Botley West Solar Farm

Applicant's Response to Rule 17 Letter (23rd October 2025)

PINS Ref: EN010147

Document Ref: EN010147/APP/18.3

Snippet - Sansom's Cottage and Sansom's Farm

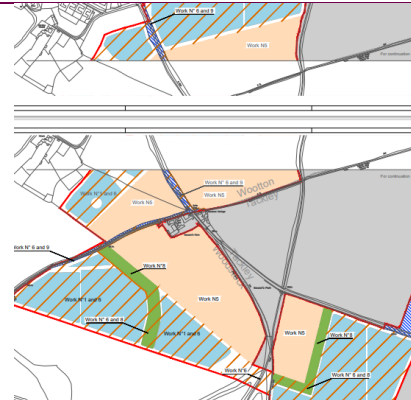
- The appendix called 'mitigation schedule' with the relevant calculations (e.g. r1 + 25m + r2) – is this appendix secured with the OLEMP or secured in the dDCO to ensure this mitigation is actually carried out? If not, why not?

The Analysis of Buffer to Farms (Appendix B PVDP Buffer Zone Analysis) [REP6-065] ("**Buffer Mitigation**") is evidence of the early phase design work undertaken by the Applicant and its application of the mitigation hierarchy, as this process helped to inform the appropriate design mitigation to be incorporated into the Project.

In summary, the Buffer Mitigation is not secured in the oLEMP because it is already secured through the inherently limited scope of the Works Plans. The draft DCO only facilitates consent to install solar arrays over land covered by Work No. 1, as shown on the Works Plans. If Work No. 1 is not shown over a piece of land, then powers of solar installation will not be available. This is the case for the buffer zones referred to in the Buffer Mitigation, as the Applicant intentionally designed the Project (as reflected through the Works Plans), such that no Work No. 1 powers are sought within the buffer zones, meaning that solar arrays may not be installed within them. This is explained further below.

Article 3 of the draft DCO seeks development consent to carry out the 'authorised development' (as set out in Schedule 1 of the DCO, which refers to different numbered work packages). Article 3(2) confirms that "*each numbered work must be situated within the corresponding numbered area shown on the works plans*". As such, the scope of the consent being sought means that the works powers in Schedule 1 of the DCO cannot be carried out in any areas where those works numbers are not shown on the Works Plans. Through this, the buffers are already embedded into the scheme design because the Works Plans would not allow solar installation in the buffer zones, as Work No. 1 is not sought over those areas. As the DCO is inherently limited, it is not necessary for these buffers from the farms to be secured separately under any other management plan (including the oLEMP or otherwise) because the Works Plans mean that the DCO would not grant powers over those buffer zones in any event. In other words, any provision in the oLEMP would seek to prevent the exercise of a consent over any area of land where the consent does not cover. This is not precise, enforceable, necessary, relevant to the development, relevant to planning or reasonable in all other respects.

By way of an example, in respect of Sansom's Cottage and Sansom's Farm, the scope of Work No. 5 on Sheets 2 and 3 of the Works Plans means that there will be no nearby installation area around those properties – see the snippet below. As a result of the scope of Work No.5, there will be approximately 160m between the fence of the installation from Sansom's Cottage; and approximately 130m between the fence of the installation from Sansom's Farm. This secures the buffer zones identified in the Buffer Mitigation.
